NON-COMPLIANCE NOTICE (NCN)

Owner:	City of Oklahoma City / Oklahoma City Water Utilities Trust	Date Issued:	04/29/2021
Contractor:	Archer Western Construction	Carollo Project No.:	10949A.30
Project Name:	WT-0159 Draper Water Treatment Plant, Various Improvements to Strengthen the Redundancy and Resiliency for Water Treatment and Storage	Notice No.:	002
Subject/Item:	120-Inch Pipe Installation (Floatation)	Spec/Dwg. Reference:	02312/ 02708

Owner:	City of Oklahoma City / Oklahoma City Water Utilities Trust	Date Issued:	12/27/2022
Contractor:	Archer Western Construction	Carollo Project No.:	10949A.30
Project Name:	WT-0159 Draper Water Treatment Plant, Various Improvements to Strengthen the Redundancy and Resiliency for Water Treatment and Storage	Notice No.:	004
Subject/Item:	Ammoniators, PRV's, Vacuum Regulating Valve Non-compliance	Spec/Dwg. Reference:	11261/P&ID's

SUBMITTAL NAME: Capital Controls Series 4100B Ammonia Feed Cabinets- Substitution request
pending

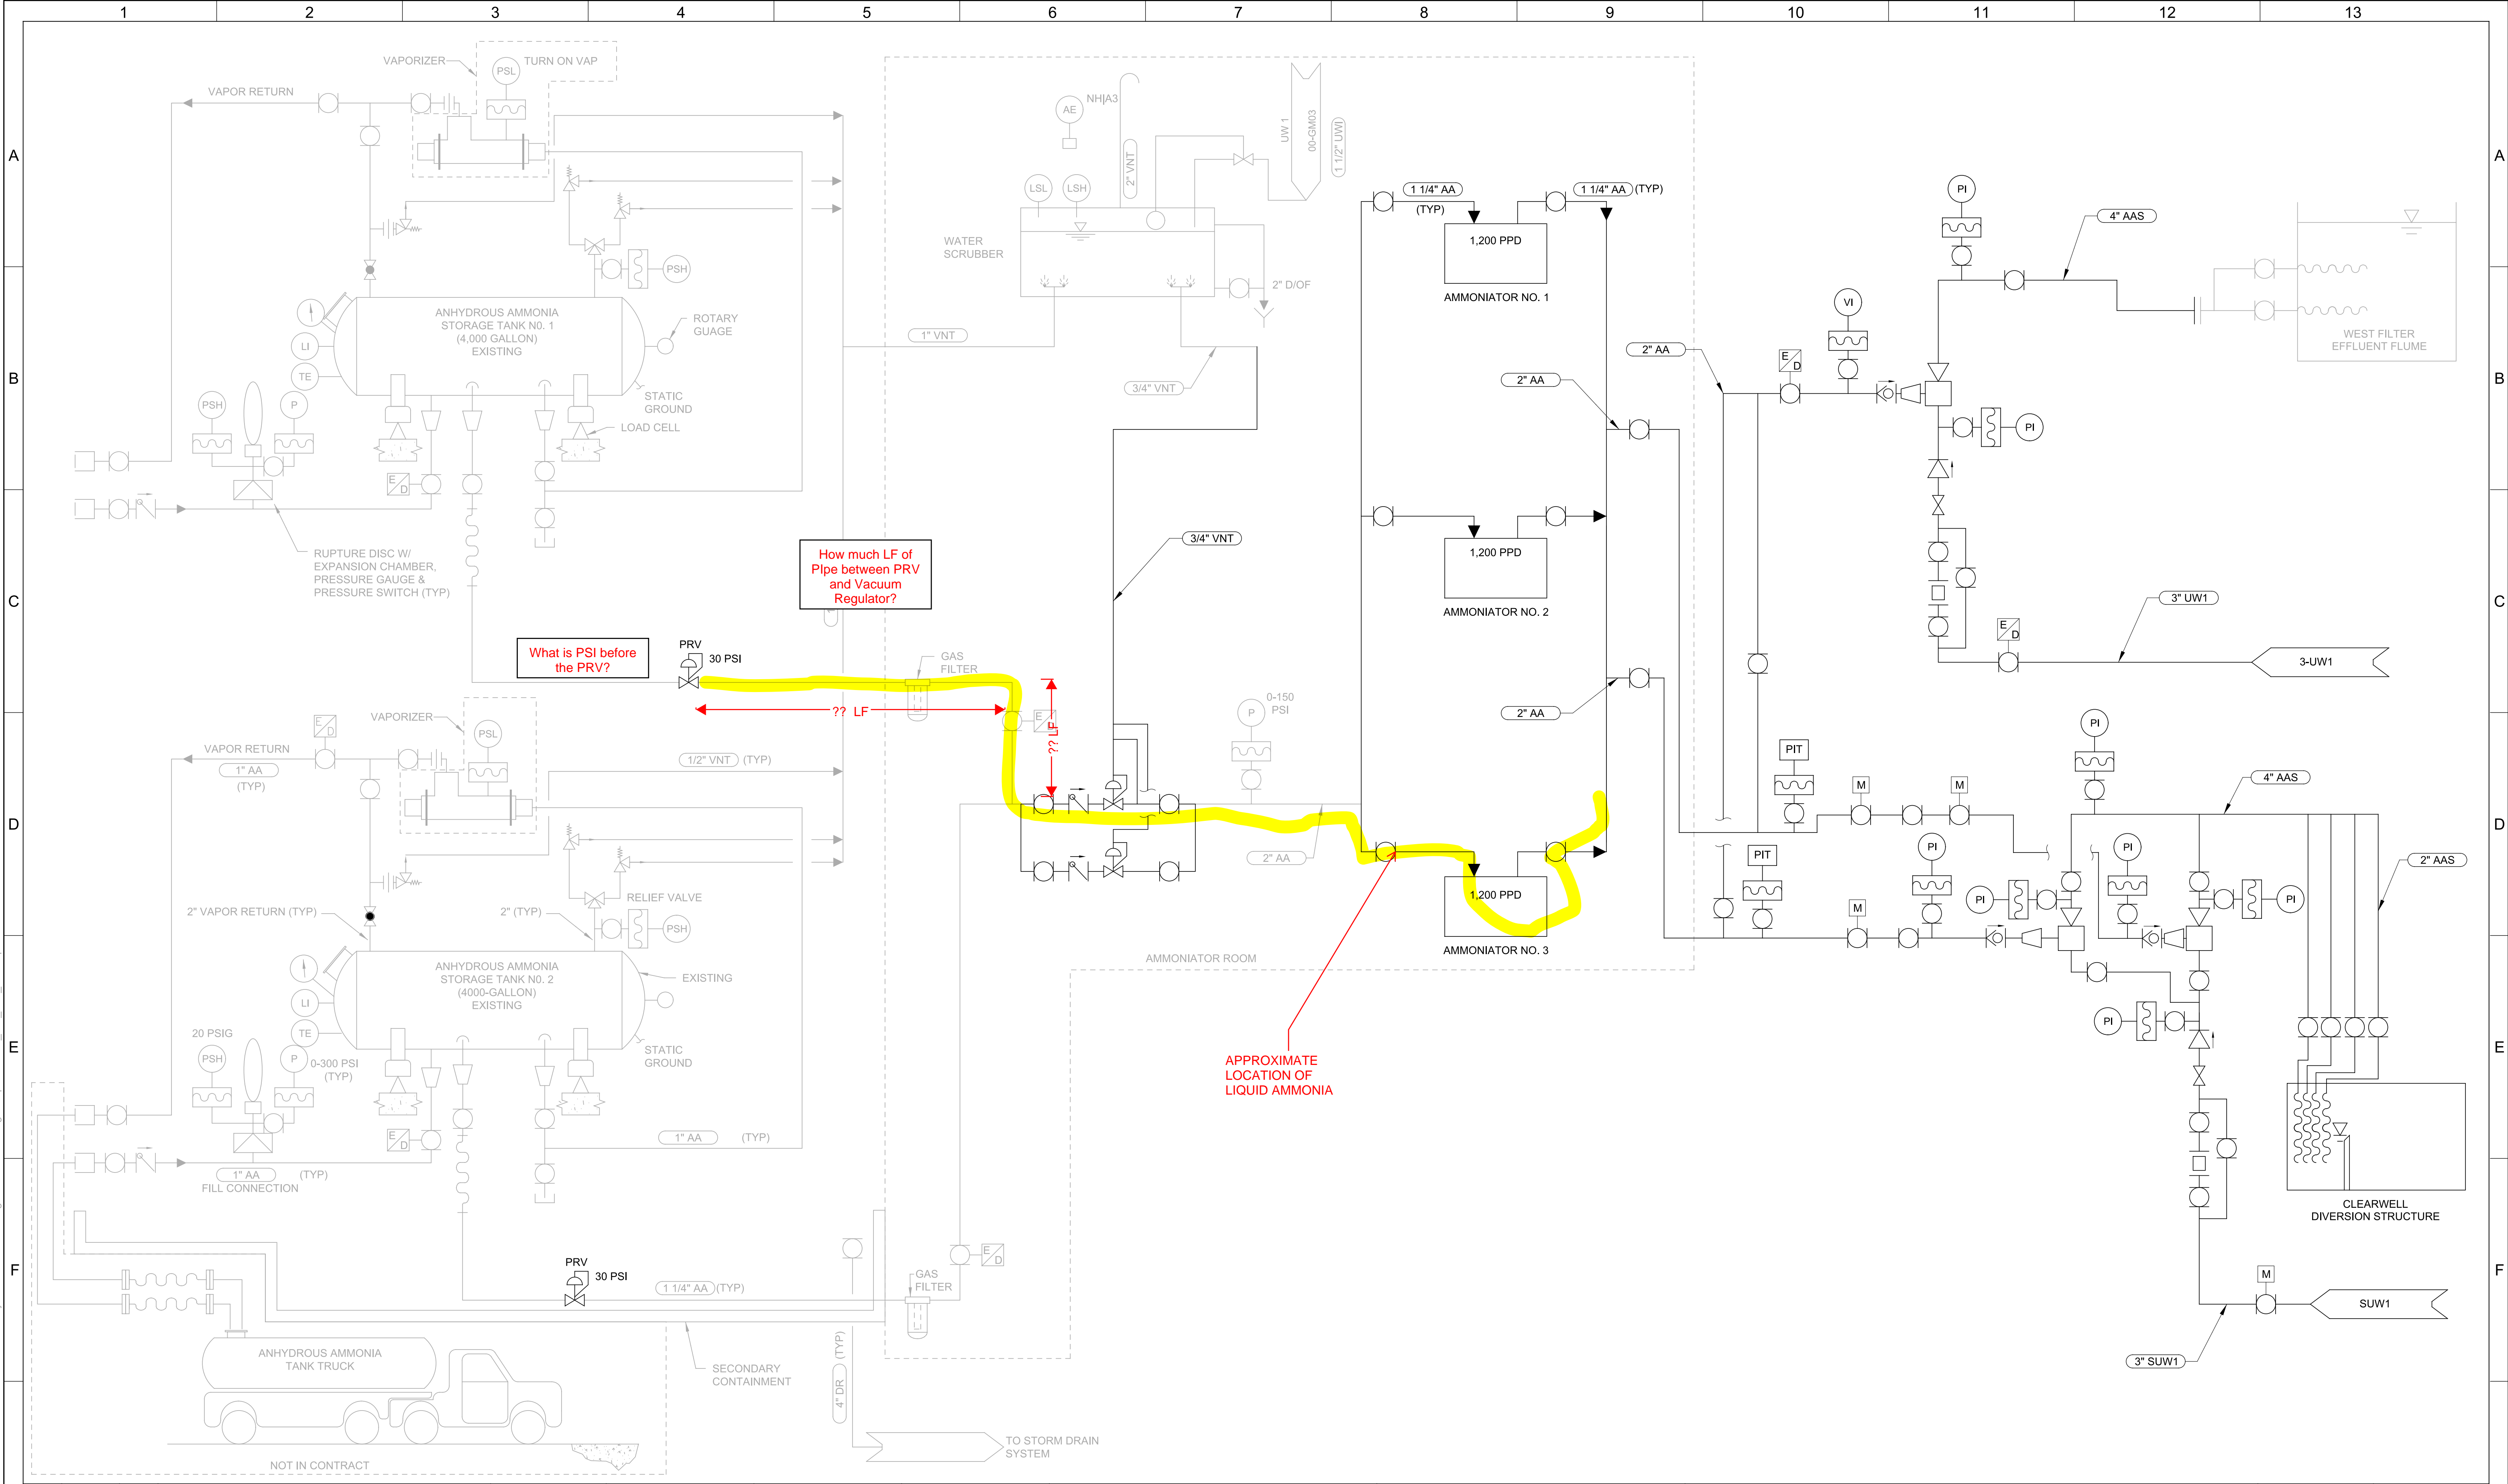
- 1) Is the PRV installed in the correct manner (vertical vs horizontal)? There seems to be some question as to whether the Horizontal installation is recommended rather than the vertical installation but the literature is not clear.

- 2) Is the PRV the correct application for this installation? Recall that the original specified PRV's were automatic rather than manual and these were replaced and sized by Denora as a replacement to the originally specified valves.

- 3) Is the PRV the correct size for the application? The piping feeding and leaving the PRV is much larger (1.5") than the PRV $\frac{3}{4}$ ". The existing PRV is 1.5".
